This is to certify that Casco Bay Ventures /Casco Bay Ventures
has permission to Build 4 new Condominium units on 16-June 4-025 (Bldg. C)
AT 3 Waterville St 016 F024001

Project:	Waterville Street Condominiums	Project No.	0111
Date:	August 15, 2003		
To:	Mr. Michael Nugent Inspection Services Manager City of Portland City Hall Room 315 389 Congress Street Portland, ME 04101	Phone No.	(207) 874-8700
		Fax No.	(207) 874-8716
From:	Will Tinkelenberg TFH Architects	Phone No.	(207) 775-6141
		Fax No.	(207) 773-0194
Re:	Review Comments	Copy to:	File

Project:	Waterville Street Condominiums	Project No.	0111
Date:	August 19, 2003		
To:	Mr. Michael Nugent Inspection Services Manager City of Portland City Hall Room 315 389 Congress Street Portland, ME 04101	Phone No.	(207) 874-8700
		Fax No.	(207) 874-8716
From:	Will Tinkelenberg TFH Architects	Phone No.	(207) 775-6141
		Fax No.	(207) 773-0194
Re:	Questions	Copy to:	File

GARAGE FLOOR MECHANICAL PI

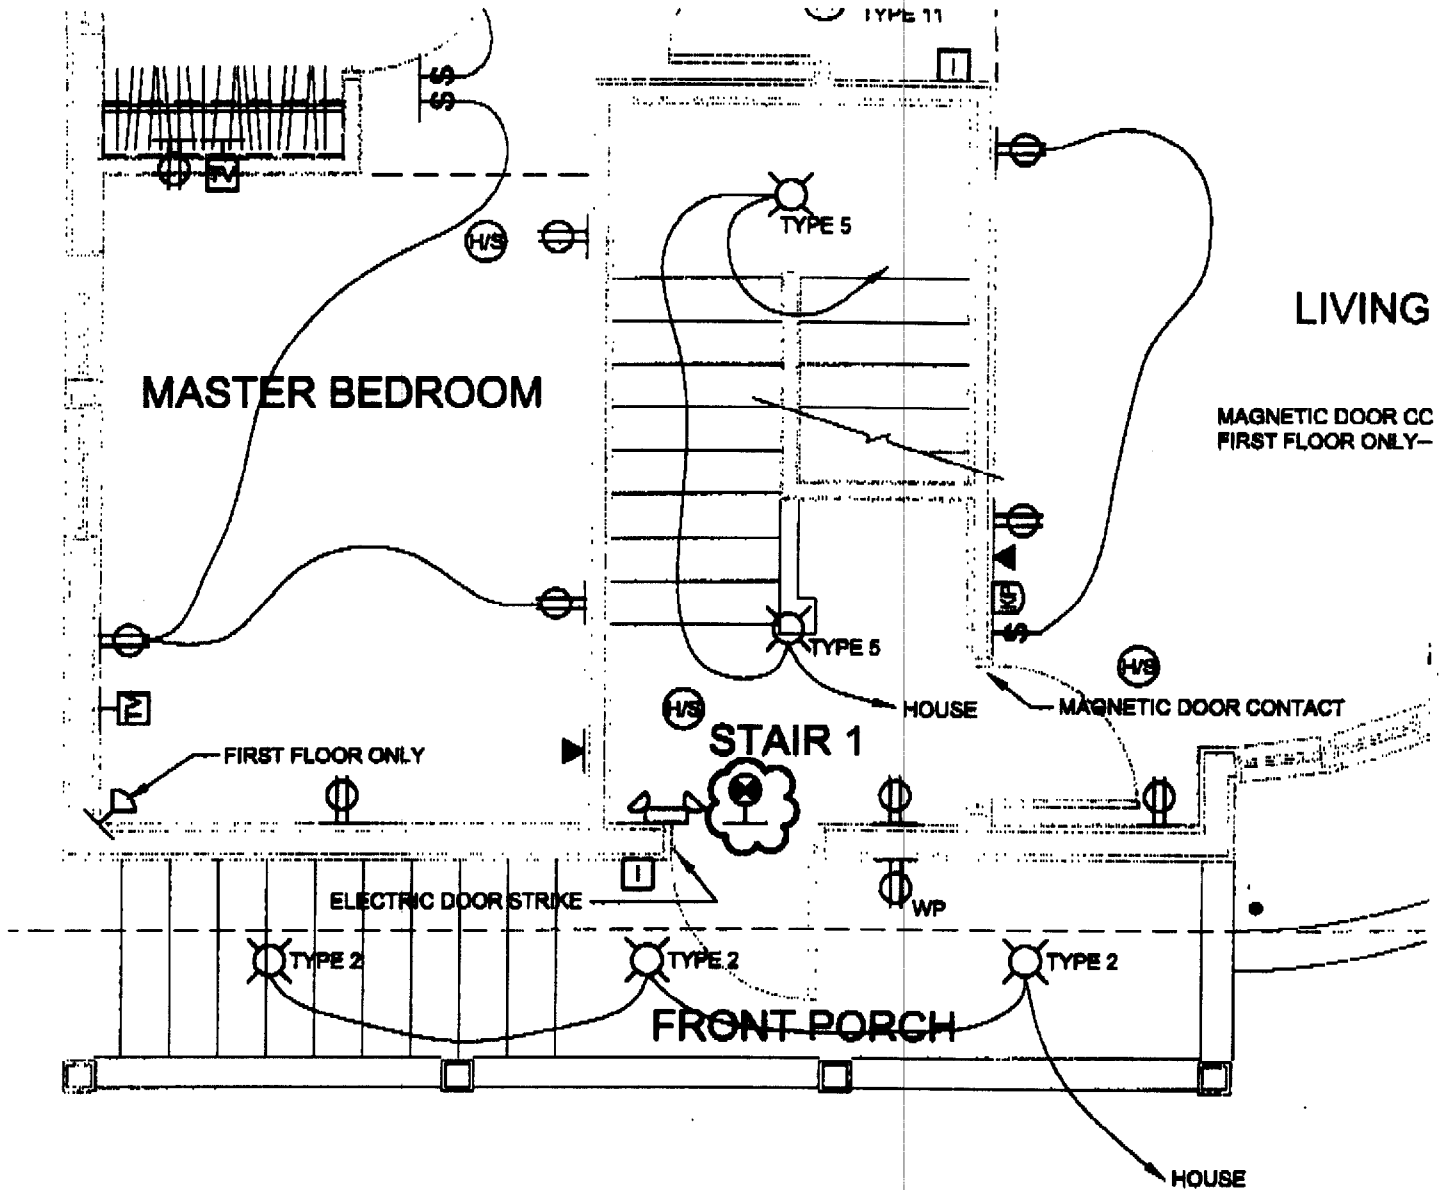
- 2.) Roof access is provided through a rated Attic Access Door in the ceiling of Stair 2 (See Fourth Floor Plan on A1-3).
- 3.) The Fire Department Connection will be located on the left side of the building near the front; we have added this to Drawing M1-1 (See Page 3).

FIRE DEPARTMENT SPRINKLER CONNECTION PIPE - INSTALL TIGHT TO WALL AND CEILING

4" STORZ FIRE DEPARTMENT CONNECTION

FIRST FLOOR ELECTRICAL PLAN (2nd, 3rd & 4th
SCALE: 1/4" = 1'-0"

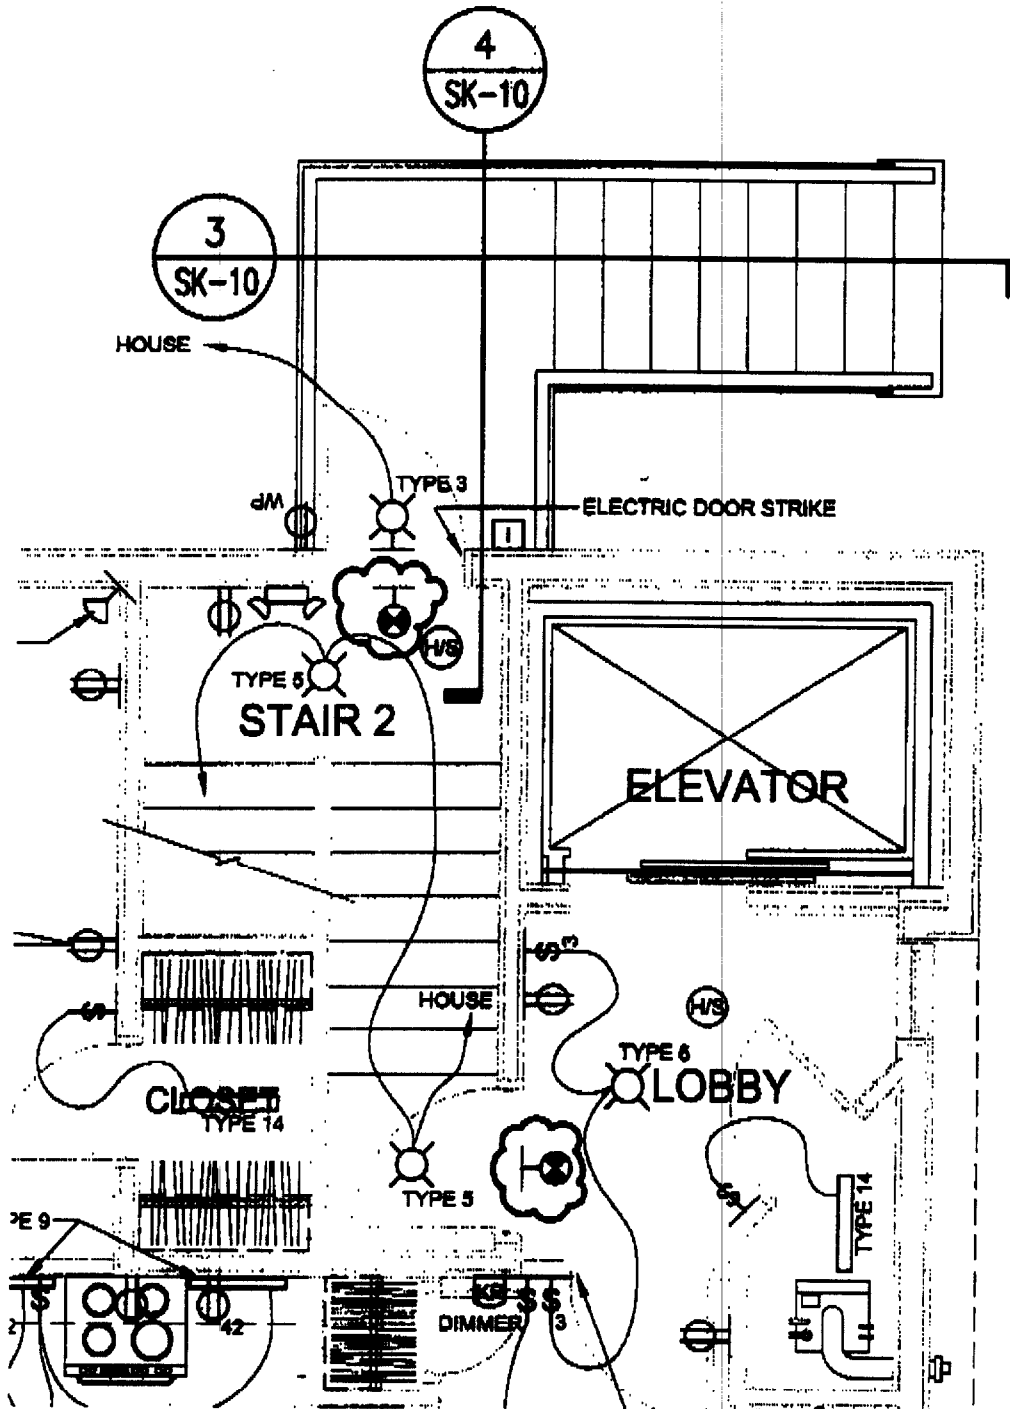
- 4.) Means of Egress Lighting, including emergency lighting, is shown on Drawing E1-1. We have added Exit signs over the exit doors from each of the Stairways and in each of the Lobbies (See Pages 4 & 5). In accordance with 1023.1, Exception 2, it is our understanding that the entrance doors into each of the units themselves do not need to be marked with Exit signs.
